Arlington Conservation Commission

Date: Thursday, April 2, 2020
Time: 7:30 PM
Location: Conducted by Remote Participation

Agenda

Notice of Intent: 93 Sunnyside Ave (continued from 2/27/2020)

PROPOSED BASEMENT
& DRIVEWAY PLANS

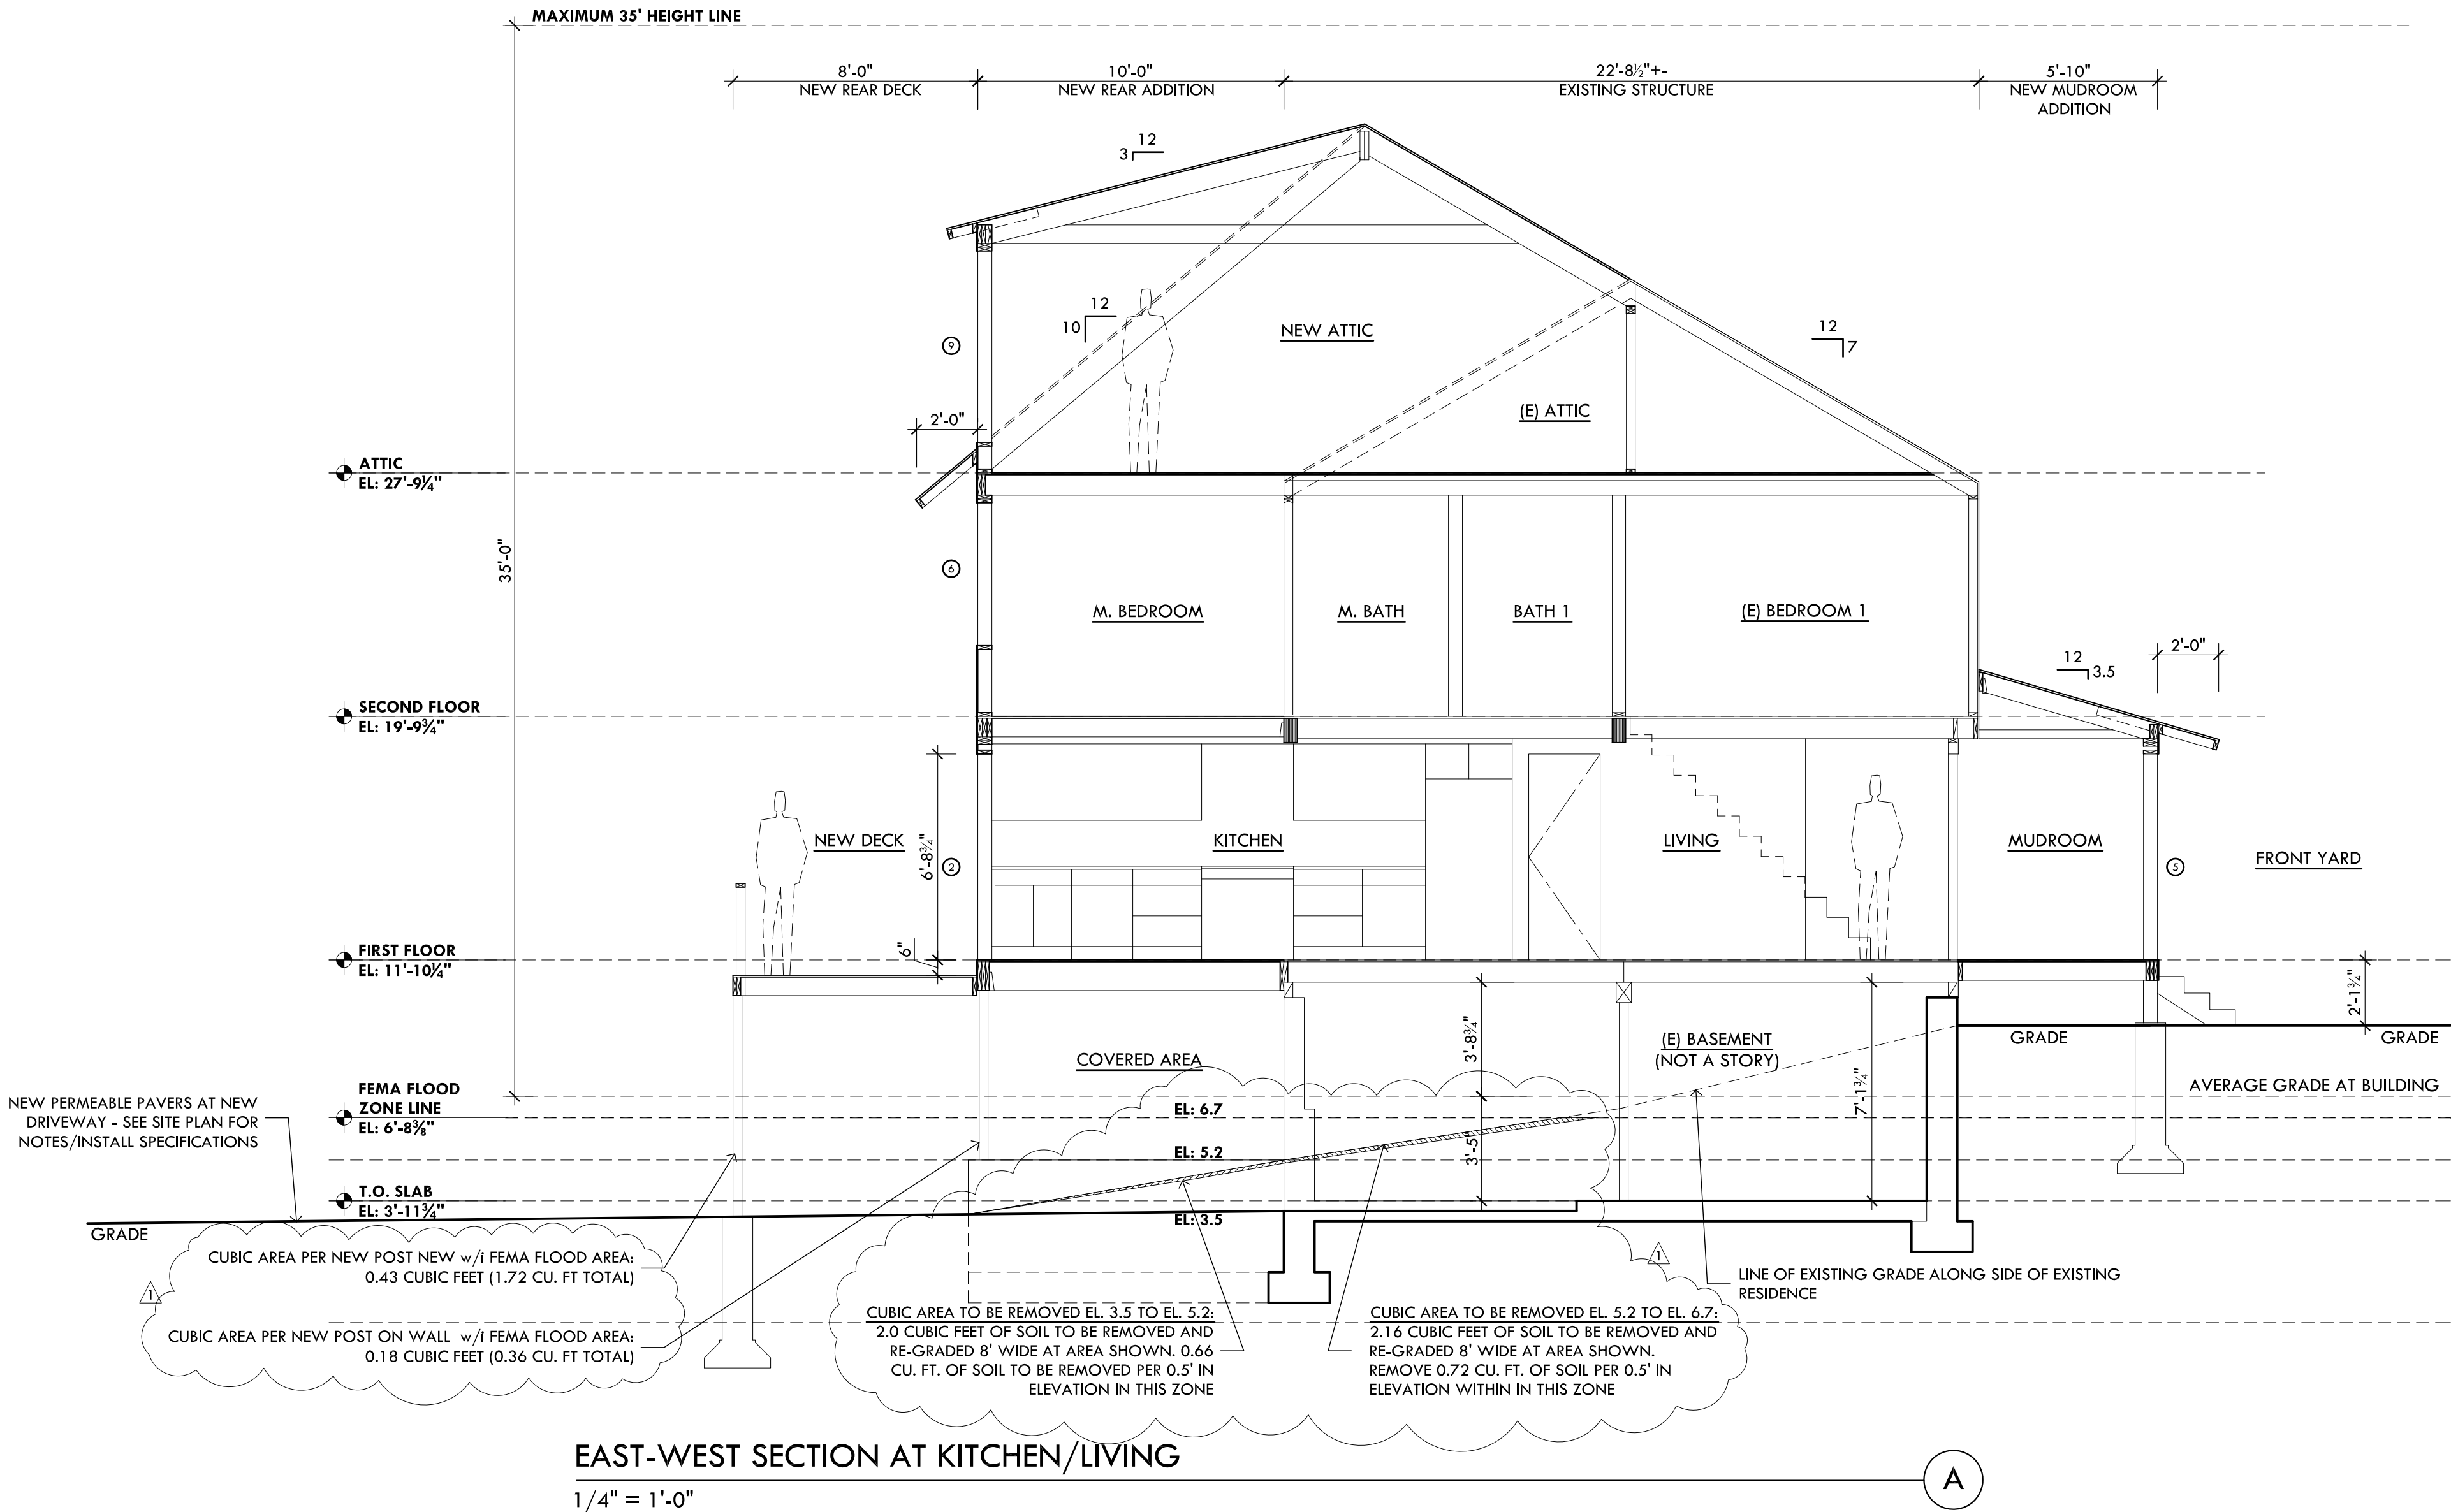
P. Heidell asked how large the proposed driveway is because the narrative and plan say different sizes. T. Blanchard stated the driveway is proposed to be 530 square feet. P. Heidell recommended shrinking the driveway size to allow more room for vegetated area.

C. Tirone asked the Applicant to clarify the proposed compensatory flood storage. T. Blanchard stated that the compensatory flood storage is proposed to be on the site yard of the property, at approximately the same elevations of encroachment. C. Tirone requested that the elevations at which the flood storage is being proposed be clarified.

D. Kaplan asked whether the water table was high. T. Blanchard stated that the water table was likely high, though he had not conducted testing to determine where exactly the water table is. D. Kaplan asked whether the proposed three dry wells would be above the water table. T. Blanchard stated that the two dry wells proposed in the front yard of the property would be above the water table. The third dry well in the backyard is more questionably above the water table. C. Tirone requested that an alternative to the third dry well be proposed in the event that the water table is too high for the third dry well currently proposed.

- 1) A new driveway design with a smaller footprint
- 2) A clarified compensatory flood storage design at the same elevations as encroachment
- 3) A more specific planting plan narrative
- 4) An alternative for the backyard dry well in the event that the water table is too high

L. Cooney stated that the proposed pervious driveway size has been reduced from 530 square feet to 466 square feet. L. Cooney also stated that the proposed vegetated buffer area would be planted with plants including Swamp Milkweed, Beebalm, Joe-pye Weed, Star Flower, and native ferns.

1. **New Driveway Design:** Driveway is reduced to 466 sq. ft. allowable for side-by-side parking for two compact cars. See attached site plan A2.1A.
2. **New compensatory flood storage design at same elevation as encroachment:** See site plan A1.0 & A4.0.
3. **Alternative for the backyard drywell in the event that the water table is too high:** If ground water is too high, new perforated VC French drain system will be installed that will direct water run off to vegetation buffer area. See site plan A2.1A.
